Re: 4210 Inglewood Drive
Our Project No. 17107

At your request the writer visited the above site July 27th 2017 where we met with you and the home owner. The purpose of our visit was to examine the existing roof structure.

EXISTING ROOF FRAMING PLAN
3/16"=1'-0"

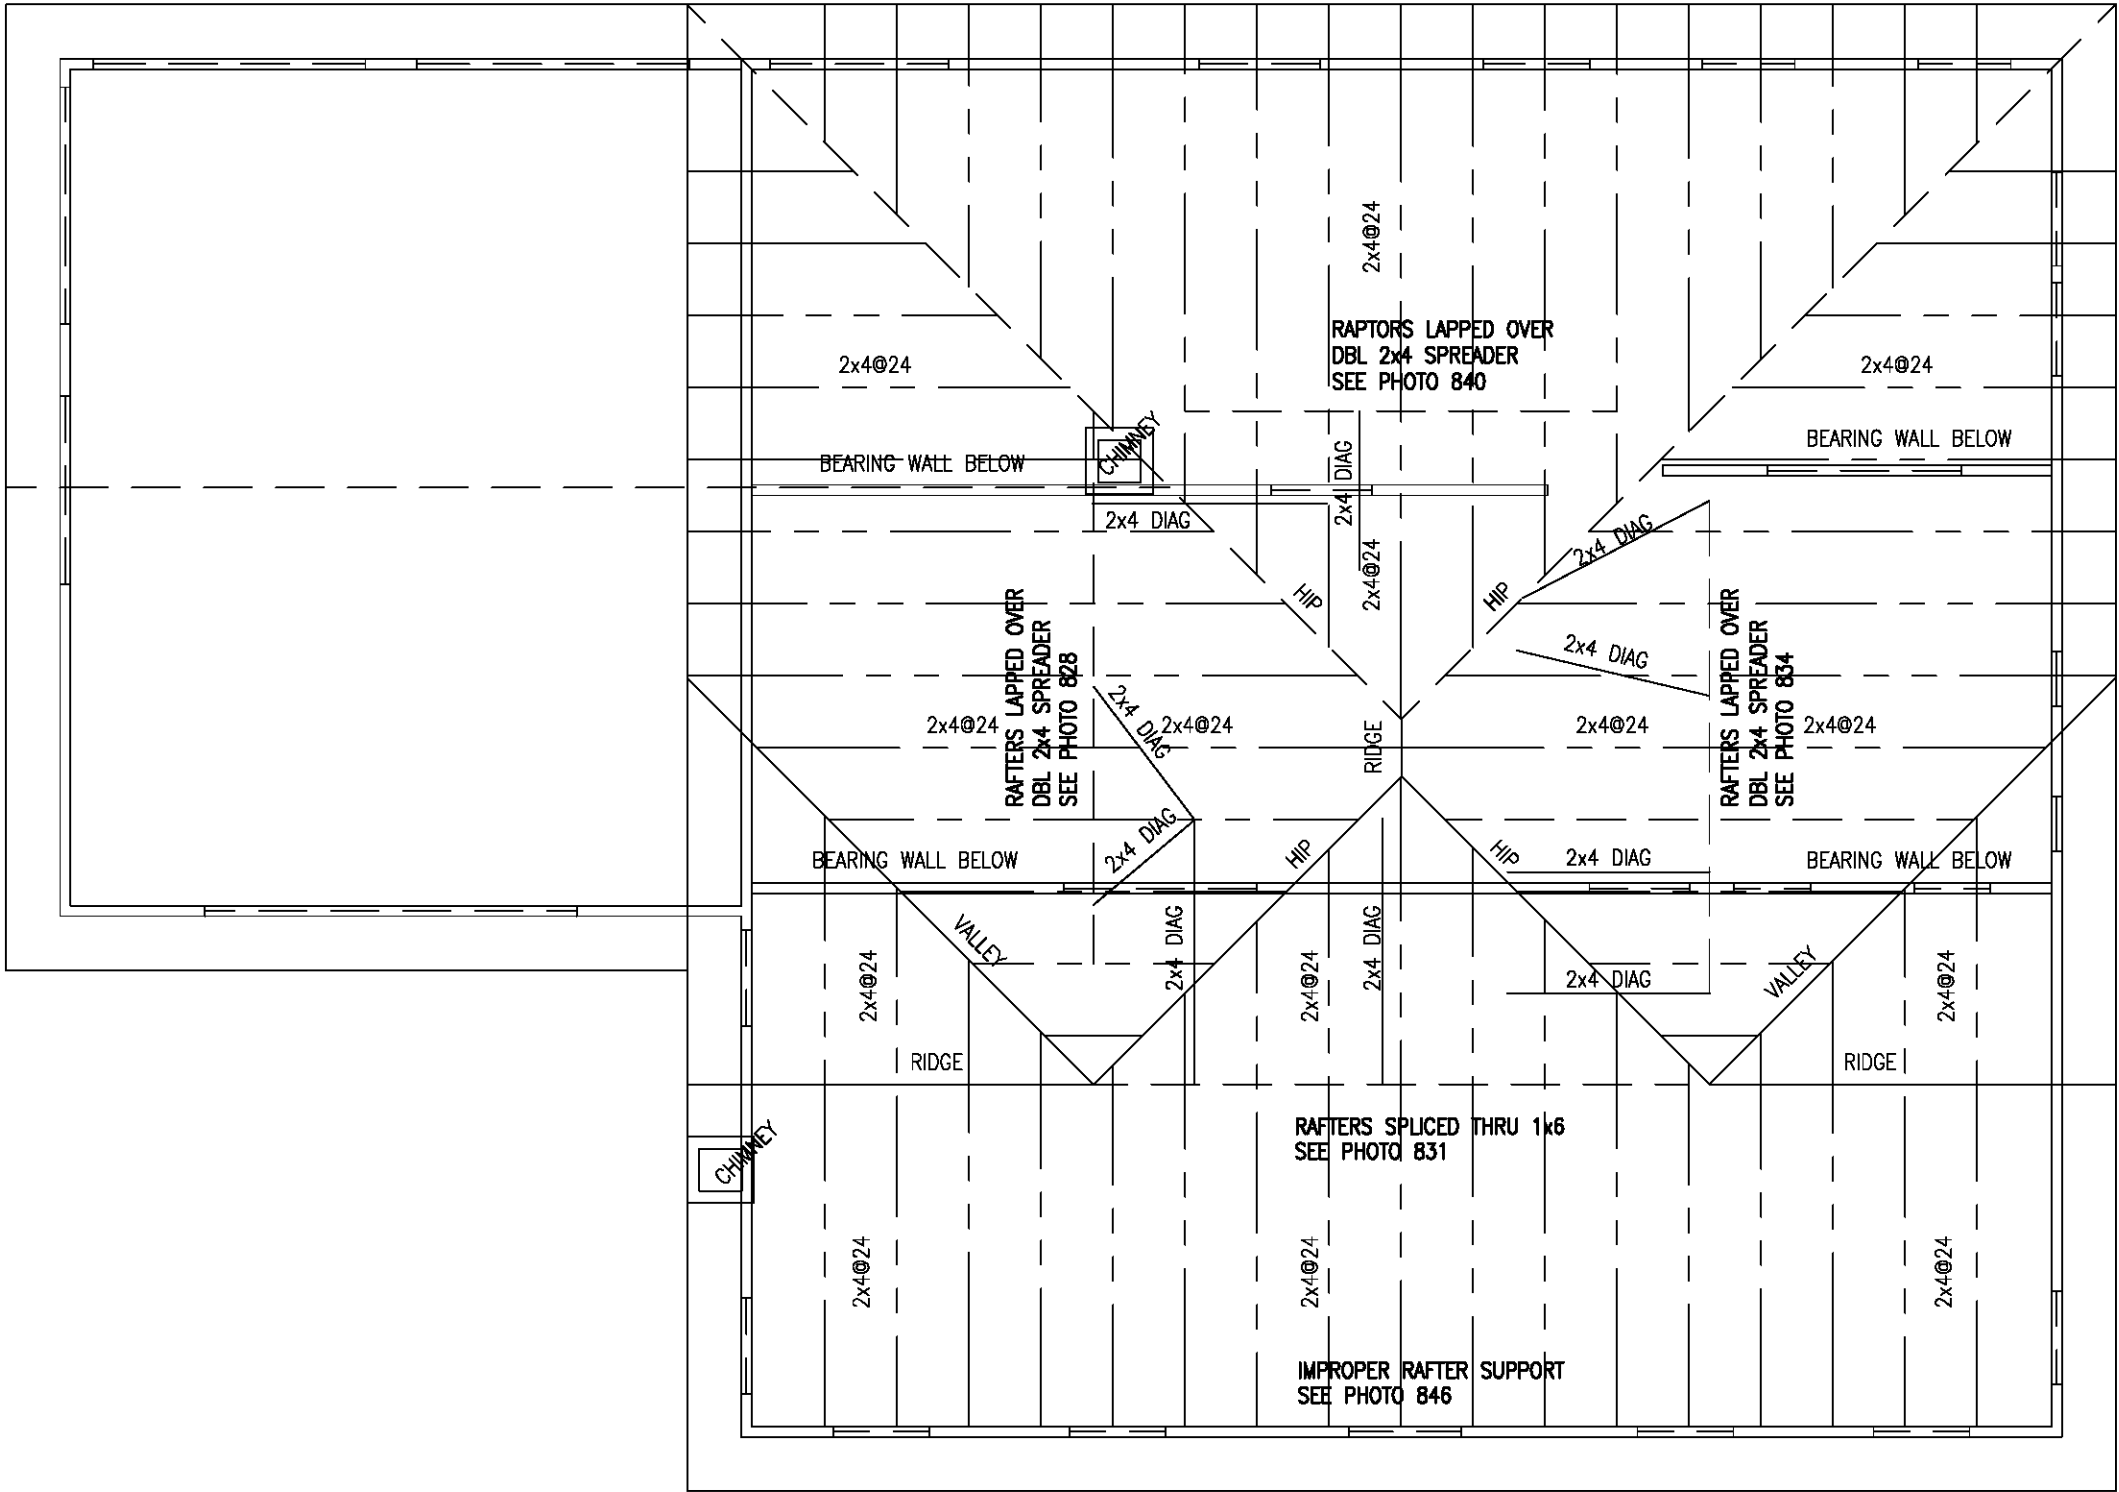
- refer to the attached existing roof framing plan S2.1
- the roof has been framed as a hip roof or cottage roof, with a gable dormer at each side
- roof rafters are 2x4@24 spanning approximately 9'-8" between supports
- rear roof hip beams are 2-2x6 spanning approximately 28'-4"
- front hip beams are 2-2x6 spanning 12'-2" from the main ridge to the dormer ridge
- only three 1x6 collar ties were observed
